PROJECT ADDENDUM

Project Name: Baker Hughes Exit Feeders

Addendum No.: 2

Date of Addendum: September 19, 2024

SCALE: 1:40	REVISION 01	CIRCUIT BAKER HUGHES	SHEET : 05 OF 11
----------------	----------------	-------------------------	---------------------

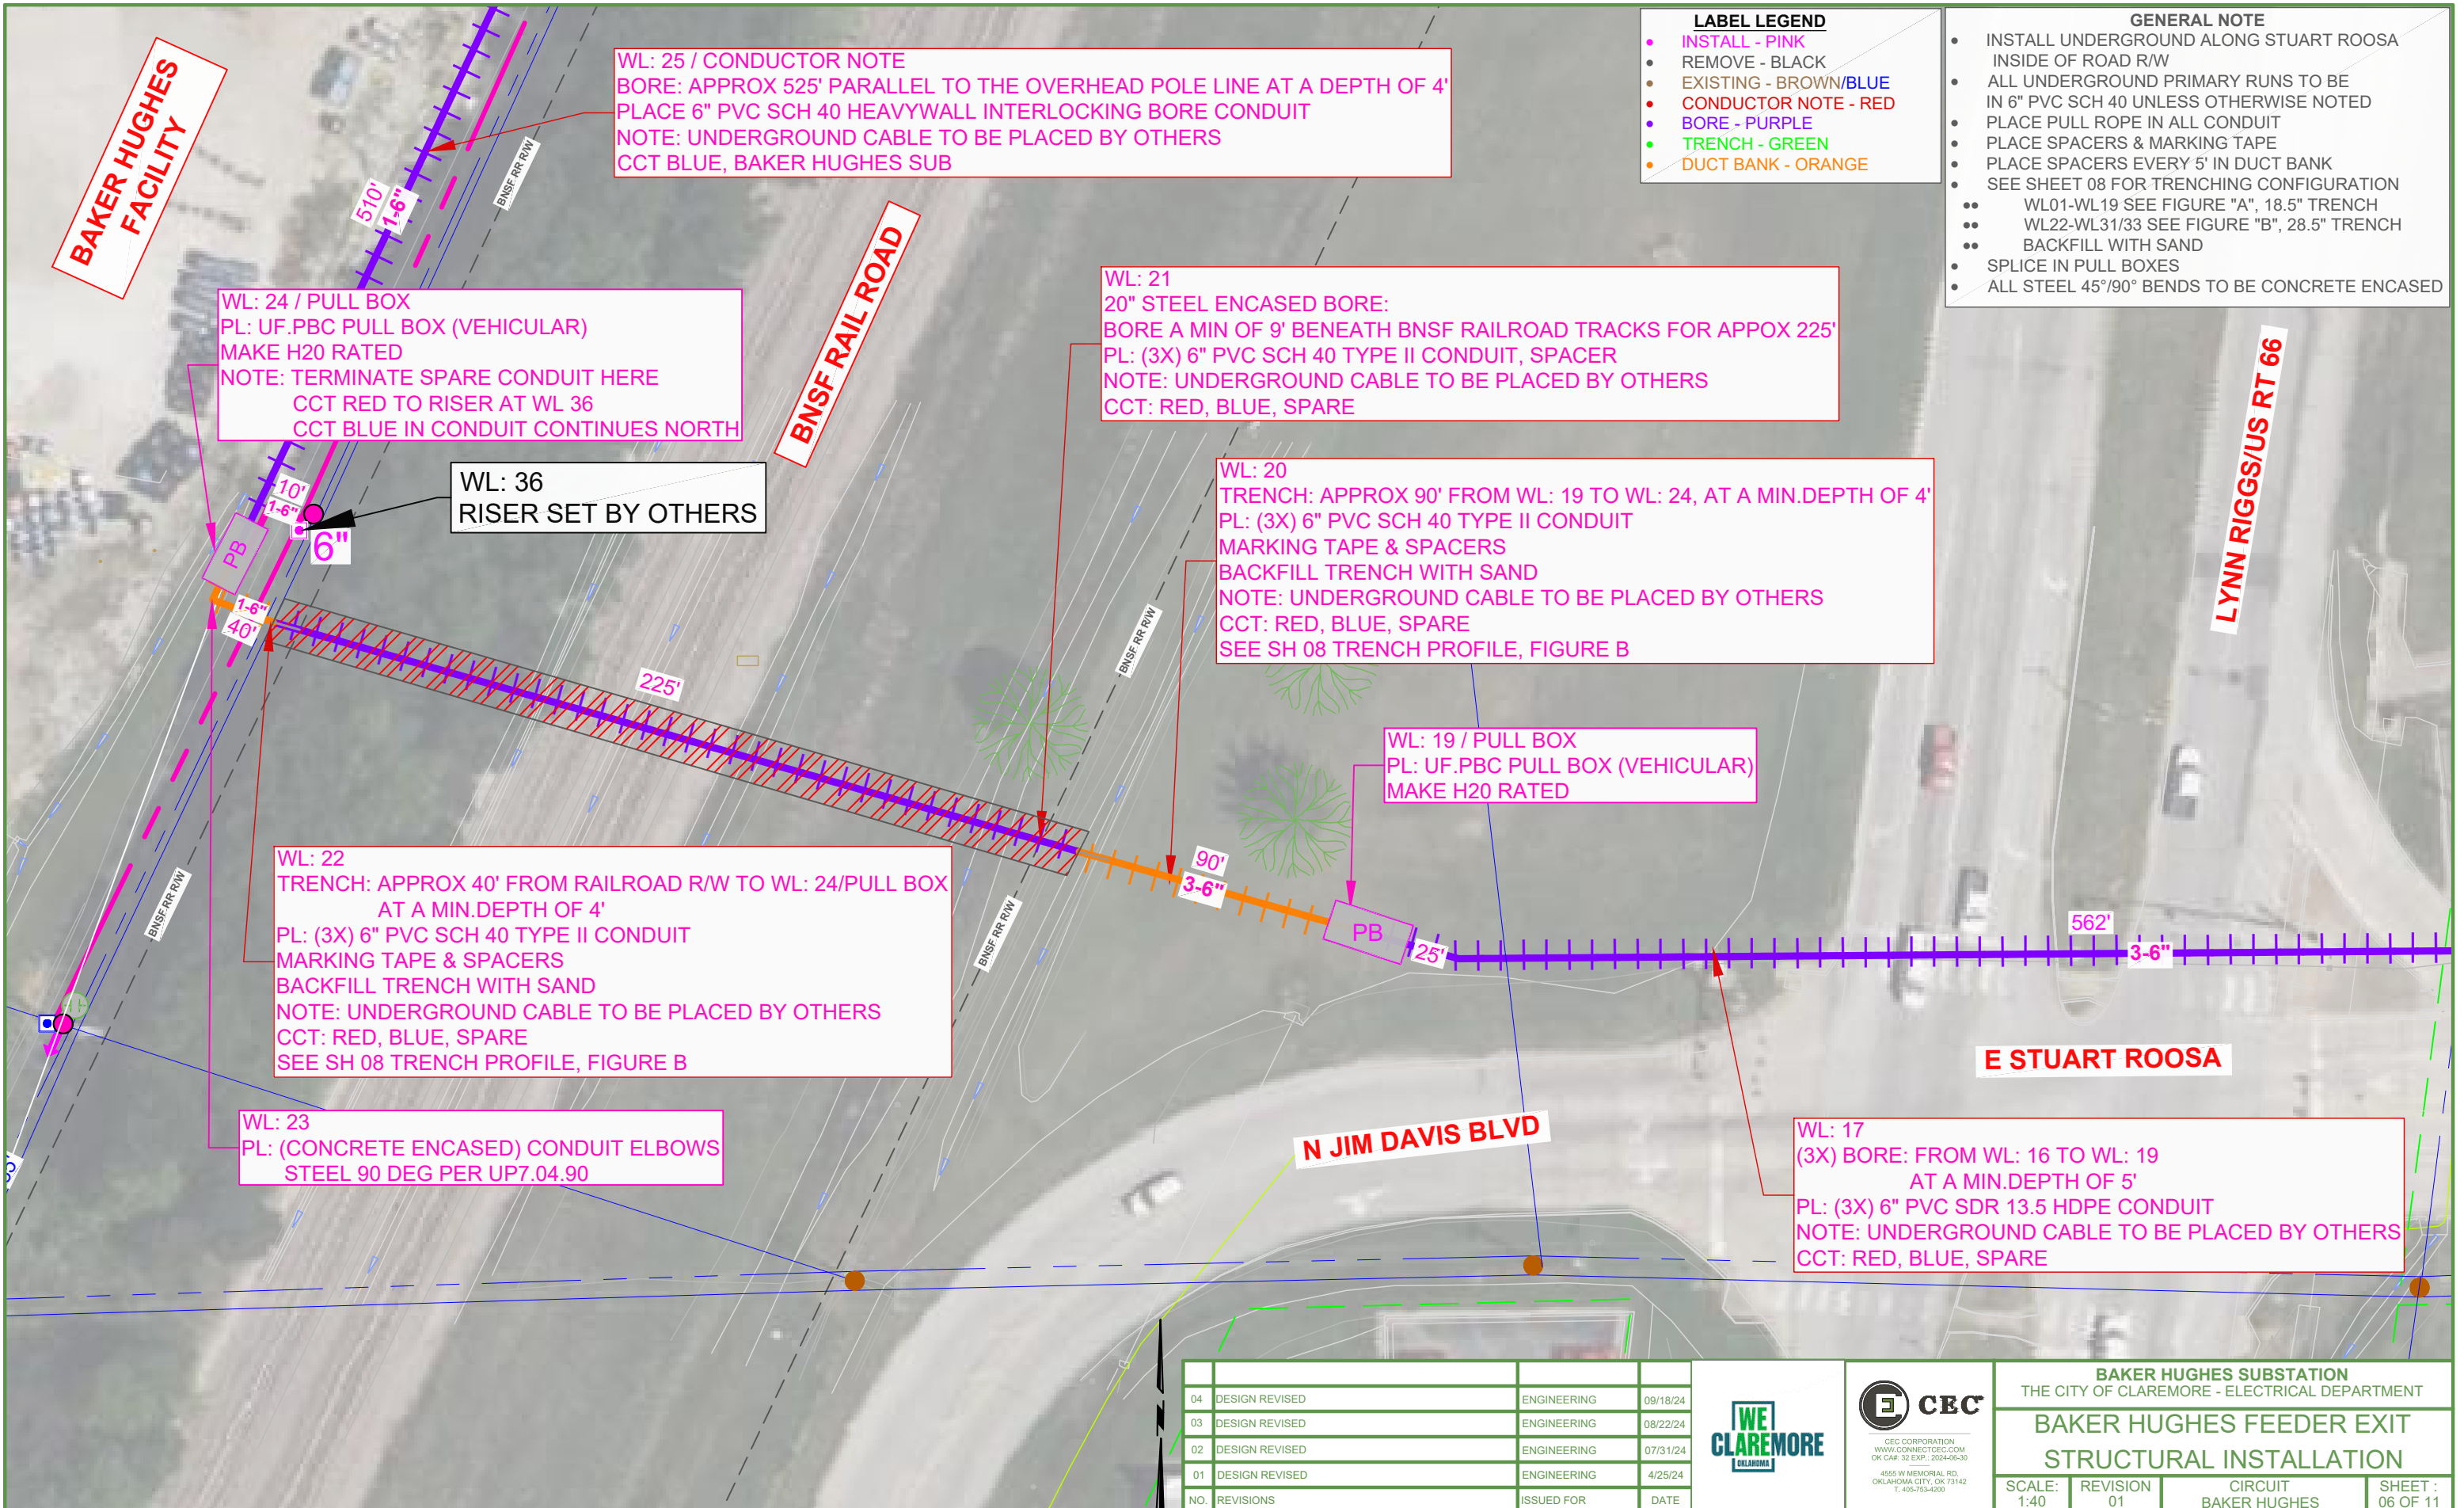
- The HDPE conduit for the non-encased Hwy 66 bore has been noted on the plans. Note this is called out as PVC SDR 13.5 HDPE. This is not PVC conduit. It is SDR 13.5 HDPE conduit.
- Bury depths have been updated to 48" min cover.
- A detail has been added for the BNSF Railroad bore.

WL: 17
 (3X) BORE: FROM WL: 16 TO WL: 19
 AT A MIN.DEPTH OF 5'
 PL: (3X) 6" PVC SDR 13.5 HDPE CONDUIT
 NOTE: UNDERGROUND CABLE TO BE PLACED BY OTHERS
 CCT: RED, BLUE, SPARE
